ALIB Composite Ltd. (Extension)

Vannara, Mouchak, kaliakoir, Gazipur

14 November 2023

Observation-2: Corrosion in steel section (Main Building)

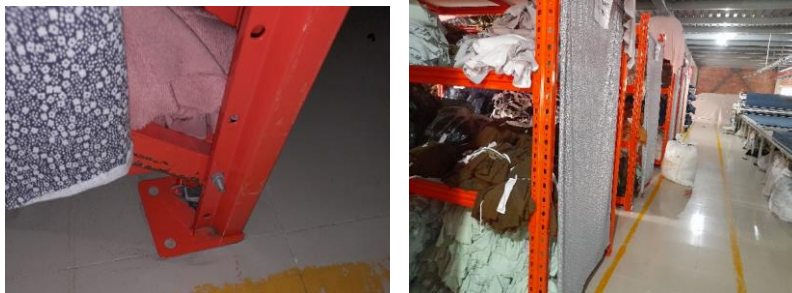
Description of observation: Corrosion was found in the steel members. Building Engineer is required to repair the corroded areas and take necessary actions to protect the steel members from corrosion.
